Interactive comment on “The yearly amount and characteristics of deep-buried phreatic evaporation in hyper-arid areas” by H. Li et al.

Note Response to Anonymous Referee #1

Hydrol. Earth Syst. Sci. Discuss., 12, C6197–C6200, 2016 www.hydrol-earth-syst-sci-discuss.net/12/C6197/2016/ © Author(s) 2016. This work is distributed under the Creative Commons Attribute 3.0 License. Interactive comment on “The yearly amount and characteristics of deep-buried phreatic evaporation in hyper-arid areas” by H. Li et al. Anonymous Referee #1 Received and published: 18 January 2016

Fig. 4. Temperature and humidity at different soil depths in the greenhouse.

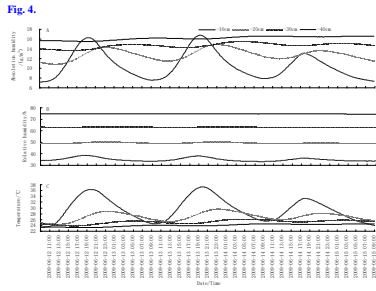
9. Section 4: the Discussion section should be rewritten according to the previous suggestions. At present, daily fluctuations of temperature and soil moisture are not shown; therefore it is difficult to follow discussions such as the one reported in Section 4.1. Similarly for Section 4.2, I am not able to see any connection between the data reported in Figure 3 and soil moisture hysteresis. Maybe the reviewer did not see our reference paper, Line 137-139: "Prior to this study, migration mechanisms were analyzed based mainly on the daily temperature and humidity of shallow soil at 0-60 cm (Li et al., 2010a; 2014a)", Li, H.S., Wang, W.F., Zhan, H.T, Qiu, F., and An. L.Z.: New Judgement on the source of soil water in extremely dry zone. *Acta Ecologica*

Sinica, 30(1): 1–7, 2010a. Li, H.S., Wang, W.F., and Liu, B.L.: The daily evaporation characteristics of deeply buried phreatic water in an extremely arid region. *J. Hydrol.*, 514 (6):172–179, 2014a. In these paper, the daily water content variation was shown as Fig. 3, the daily temperature and humidity was shown as Fig. 4.

Here is Fig. 3 Here is Fig. 4
